Petition Number: 2023-042
General Location Identifier: 11907801

Rezoning Transportation Analysis Petition Number: 2023-042

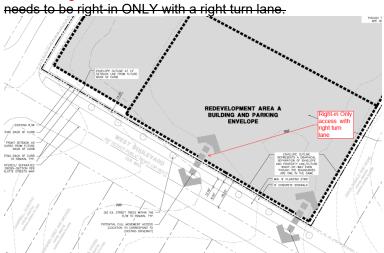
- Under future UDO guidelines this project would require a Comprehensive Transportation Review and mitigation. In leu of providing CTR, CDOT REQUESTS the petitioner provide APS pushbuttons and pedestrian ramp upgrades at the existing traffic signal at the intersection of West Boulevard and South Mint Street.
- 4. Outstanding Comment from 7.26.23: In coordination with NCDOT, revise site plan and conditional note(s) to commit to construct bicycle facilities by installing a 12' multi-use path on West Boulevard to meet the Council-adopted Charlotte BIKES Policy. Charlotte Streets Map calls for buffered bike lanes, NCDOT will not allow buffered bike lanes on West Boulevard. Multi-use paths maintained by the City shall meet ADA/PROWAG requirements.

Clarifying Comment from 11.27.23: Proposed streetscape is only 8'. Due to NCDOT not wanting a bike lane on their street, this needs to be a 12' shared use path.

Clarifying Comment from 12.21.23: Revise proposed streetscape to a 12' multi-use path to support council adopted Charlotte BIKES policy.

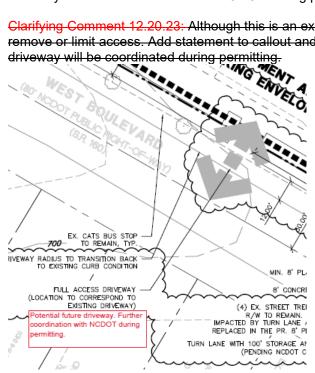
7. Outstanding Comment from 7.26.23: Per coordination with NCDOT, the site access on West Boulevard

Clarifying Comment 11.27.23: Revise site plane and conditional note to read, "Potential future driveway. Further coordination with NCDOT during permitting."

Clarifying Comment 12.20.23: Although this is an existing driveway, NCDOT has the authority to remove or limit access. Add statement to callout and conditional note that approval of West Boulevard

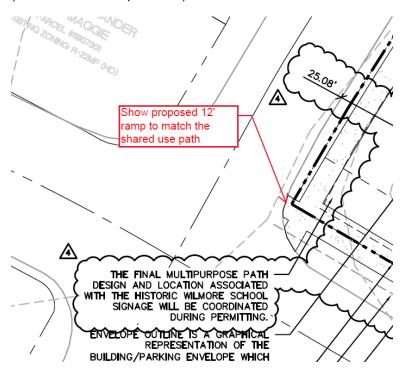
8. Outstanding Comment from 7.26.23: Per coordination with NCDOT, remove this site access along

9. New Comment 3.20.24: Show a proposed 12' ramp to match the shared use path width (ADA/PROWAG requirement).
